Addendum No. 2
February 2, 2026

Project: Sioux Falls Washington and Roosevelt High School Auditorium Renovations
Sioux Falls, South Dakota
Project #3021

Architect: Architecture Incorporated

W9.22

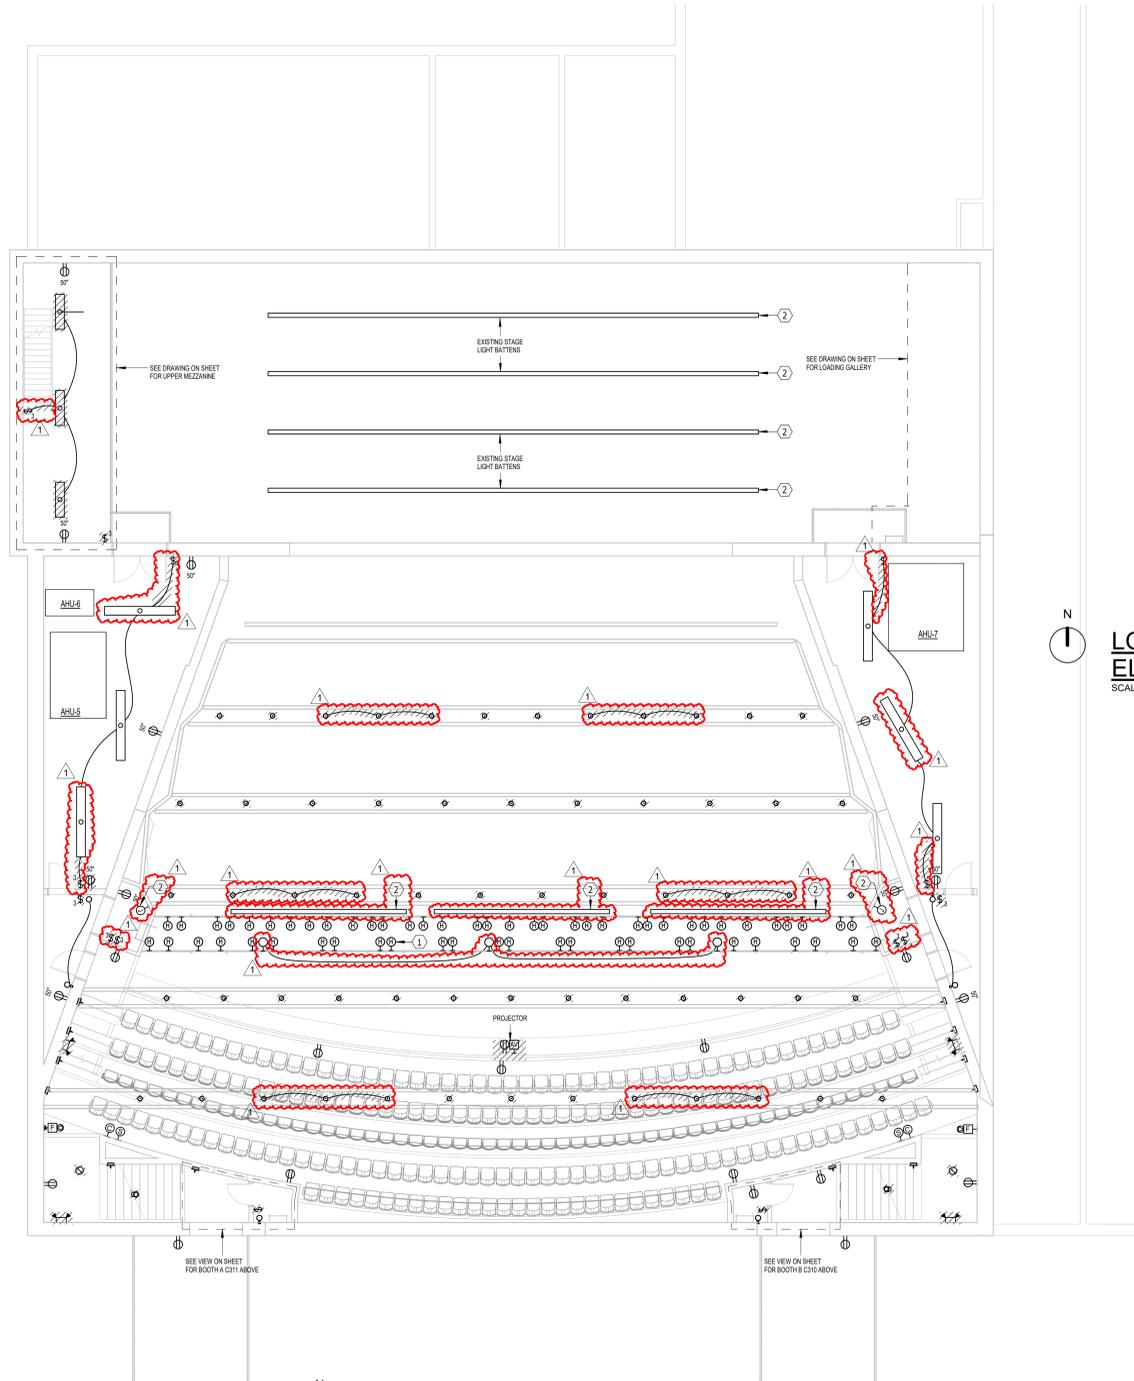
- a) At Upper Mezzanine detail, see added switch and hatching at top of stairs as shown on revised plan sheet dated 2-2-2026.
- b) At Loading Gallery detail, see added existing light fixtures to remain and hatched switch to be demolished as shown on revised plan sheet dated 2-2-2026.
- c) At Catwalk location, see Qty (5) added Theatrical Lighting Battens with electrical note #2 tags as shown on revised plan sheet dated 2-2-2026.
- d) At the Catwalk, update Qty (3) hoists to lights and see existing raceway added as shown on revised plan sheet dated 2-2-2026.
- e) Add hatching to light switches on both sides of the catwalk as shown on revised plan sheet dated 2-2-2026.
- f) Demo electrical connections from existing house lights in (8) locations in Auditorium as shown on revised plan sheet dated 2-2-2026 to allow for refeeding of New Type L fixtures with inverter backup power.

- a) At Balcony, see added Exit lights and hatching at each of (2) exits as shown on revised plan sheet dated 2-2-2026.

W9.32

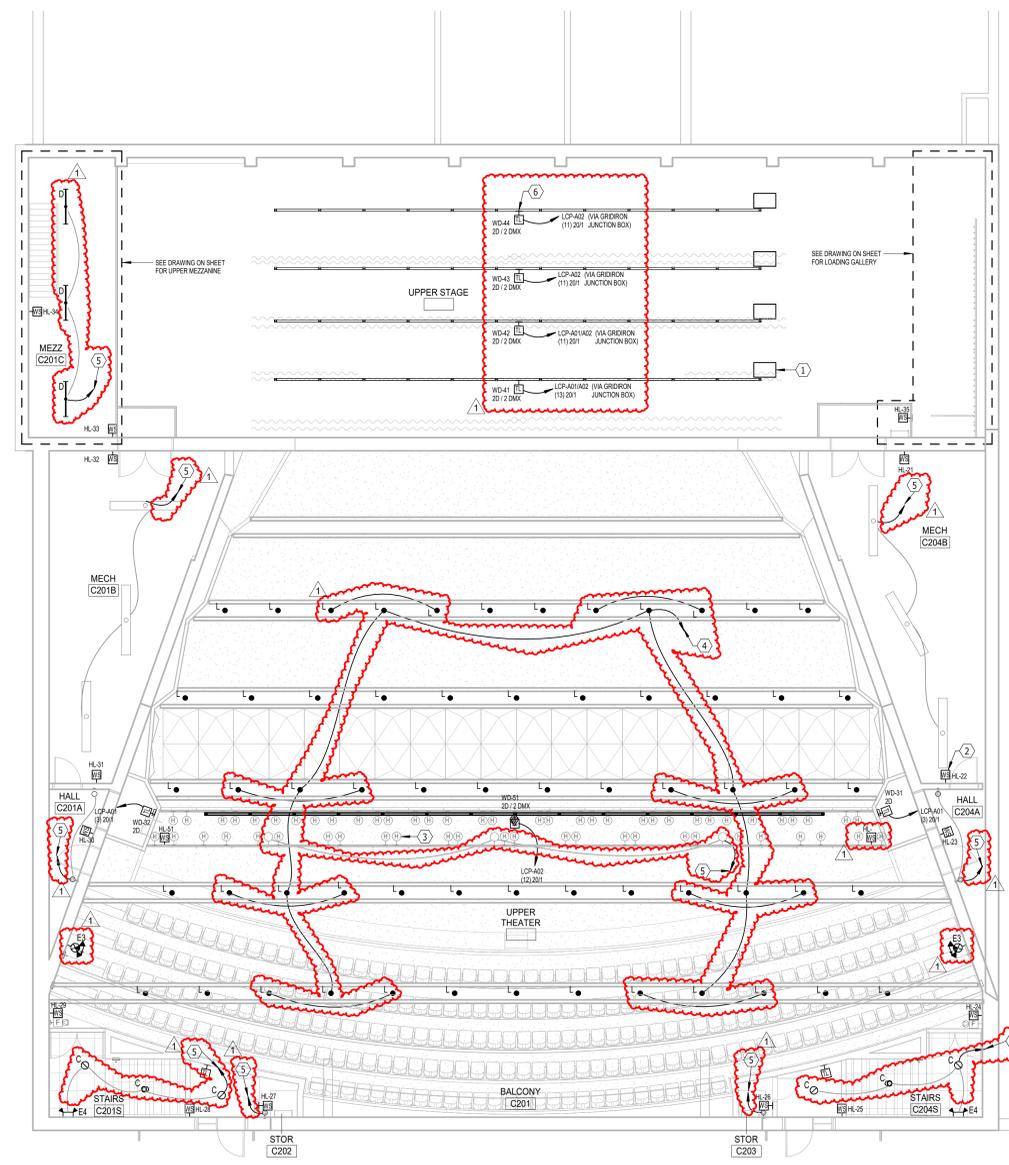
- a) Add Electrical Note No. 4 which reads “CONNECT THIS CIRCUIT THRU INVERTER "INV-EM" VIA A BCELTS DEVICE. SEE THEATRICAL LIGHTING AND POWER RISER DIAGRAM.” See added electrical note No. 4 tag and homerun tag in Upper Theater and

additional raceway to connect Type L fixtures to emergency inverter as shown on revised plan sheets dated 2-2-2026.

- b) Add Electrical Note No. 5 which reads “PROVIDE NEW HOMERUN TO PANEL LCH-2 VIA LIGHTING RELAY PANEL (LRP) AS REQUIRED TO CONTROL THE LIGHT FIXTURE GROUP SHOWN.” See added electrical note No. 5 tag in multiple locations on revised plan sheet dated 2-2-2026.

- c) Add Electrical Note No. 6 which reads “THEATRICAL LIGHTING WIRING DEVICE. I.D. NUMBER AS INDICATED. PROVIDE POWER CIRCUITS INDICATED WITH SEPARATE NEUTRALS. PROVIDE QUANTITY OF DATA DROPS INDICATED, WHICH SHALL TERMINATE AT THEATER CONTROL EQUIPMENT IN HALL C103D. SEE STAGE LIGHTING WIRE DEVICE SCHEDULE ON SHEET QT5.01. TYPICAL.” See added electrical note No. 6 tag on revised plan sheet dated 2-2-2026.

- d) See updated symbol at Type E3 Exit light locations on Balcony C201 as shown on revised plan sheet dated 2-2-2026.
- e) At Upper Mezzanine Detail, Add Wall Switch as shown on revised plan sheet dated 2-2-2026.

- f) At Upper Stage, update circuit quantities for new theatrical lighting battens as shown as shown on revised plan sheet dated 2-2-2026.
- g) At Booth A C311 Detail and Booth B C311 Detail, See added Theatrical Lighting devices shown on revised plan sheet dated 2-2-2026.

R9.21

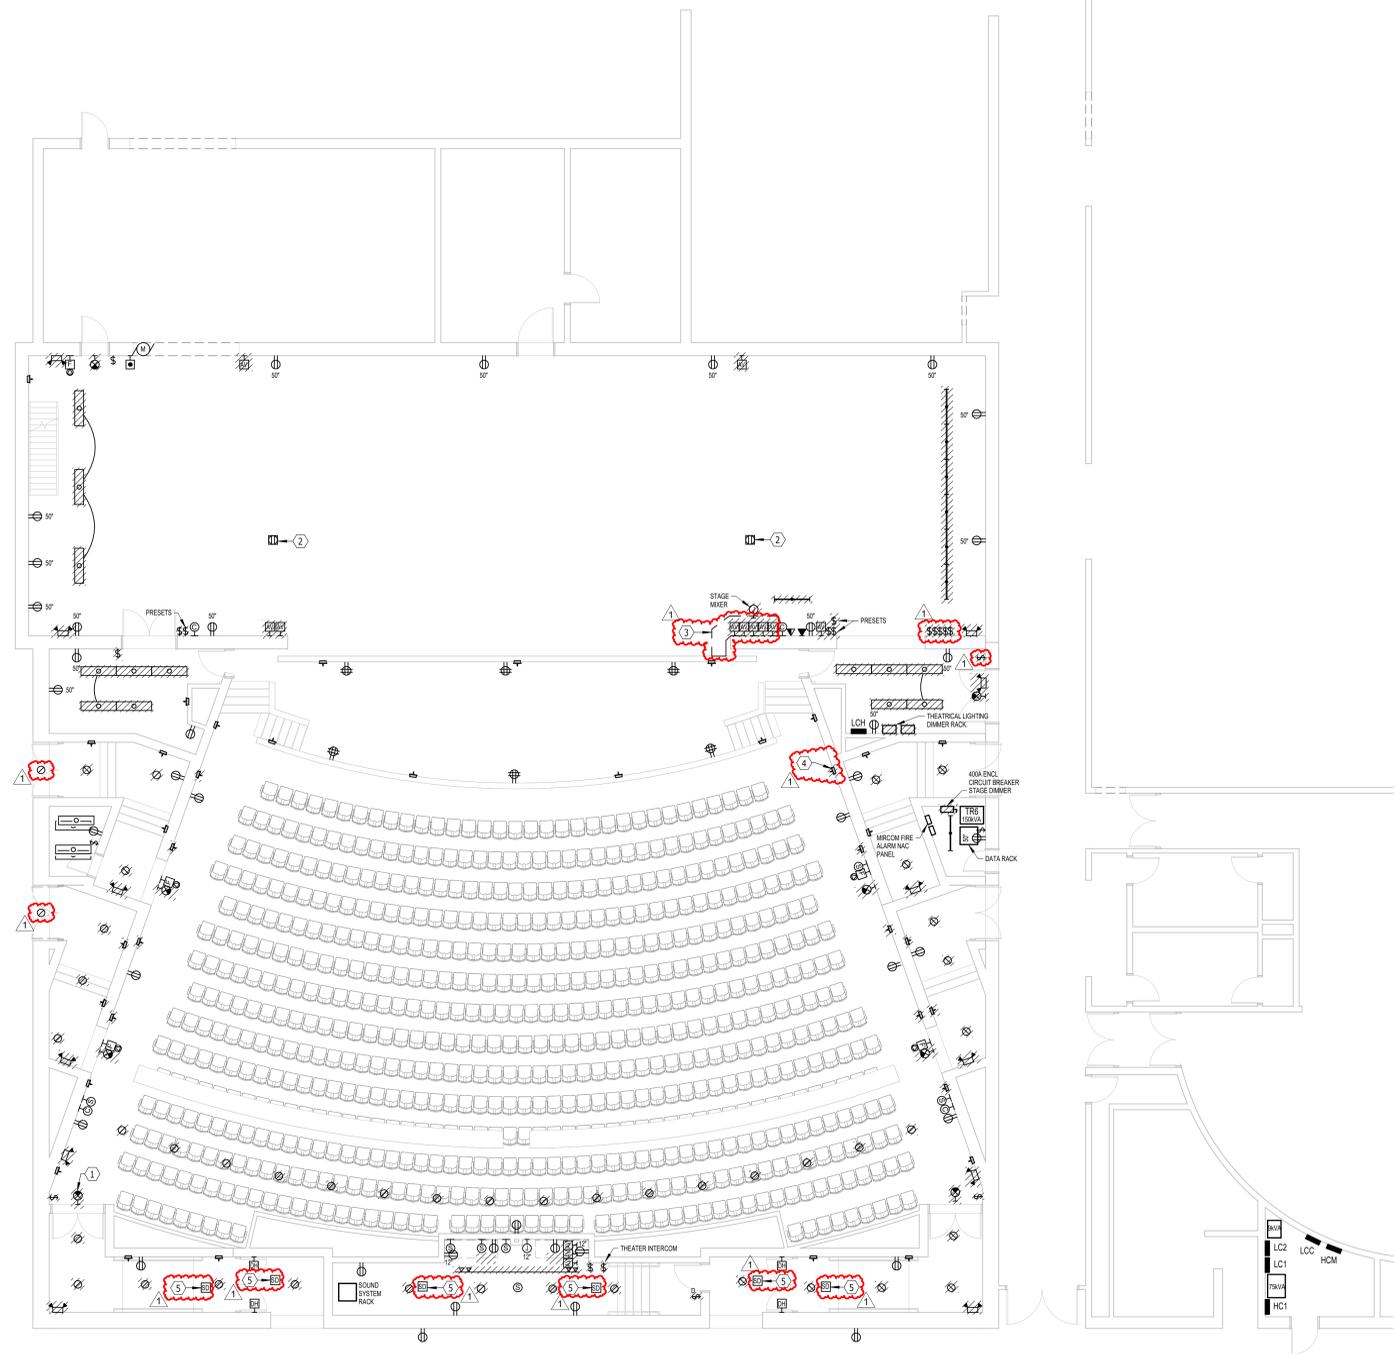
- a) Add Electrical Note No. 3 which reads “COORDINATE WITH GC TO REMOVE AND REINSTALL ENOUGH FLOORING TO ALLOW NEW RACEWAY TO BE INSTALLED TO THE NEW DEVICES IN THE ORCHESTRA PIT.” See added electrical note tag No. 3 at proscenium wall and demo outline as shown on revised plan sheet dated 2-2-2026.

- b) Add Electrical Note No. 4 which reads “AT EXISTING AISLE LIGHT LOCATIONS SHOWN TO BE DEMOLISHED, PROVIDE A BLANK COVER PLATE PAINTED TO MATCH THE BRICK. TYPICAL.” See added electrical note tag No. 4 on revised plan sheet dated 2-2-2026.

- c) Add Electrical Note No. 5 which reads “REMOVE AND REINSTALL EXISTING CEILING MOUNTED DEVICES WITHIN THIS SPACE THAT ARE NOT HATCHED FOR DEMO. TYPICAL.” See added electrical note No. 5 tag and smoke detectors added in Vestibules C101B, C101C and CNTRL RM C101A as shown on revised plan sheet dated 2-2-2026.

- d) Remove hatching from 2 downlights at West exits from auditorium as shown on revised plan sheet dated 2-2-2026.
- e) Add hatching to switches located on southeast corner of stage as shown on revised plan sheet dated 2-2-2026.

R9.33

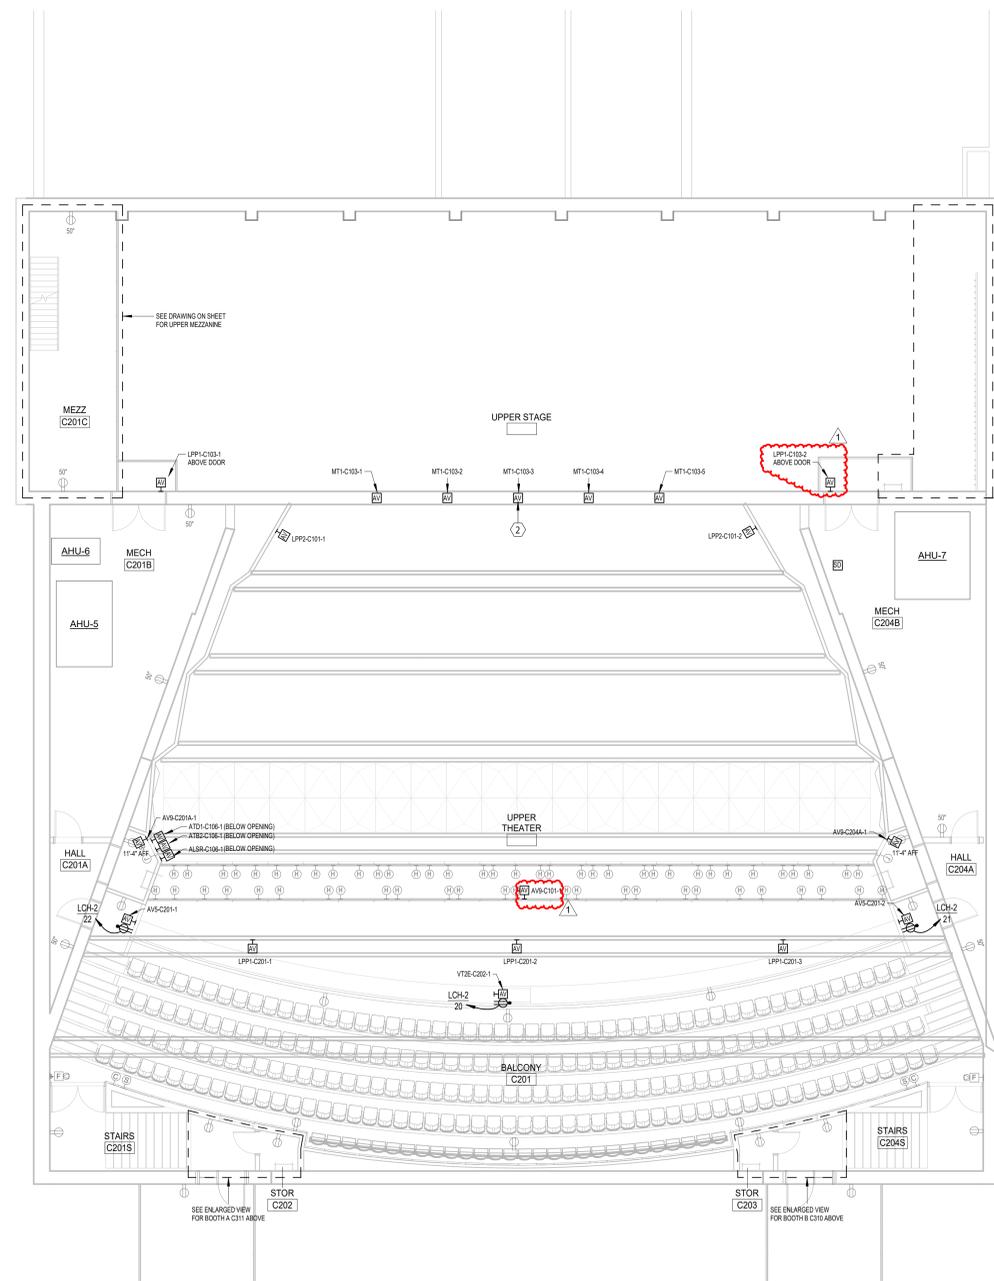
- a) At Booth A C311 Detail and Booth B C311 Detail, see updated devices heights as shown on revised plan sheet dated 2-2-2026.
- b) At Upper Stage, see updated name of device LPP1-C103-2 as shown on revised plan sheet dated 2-2-2026.
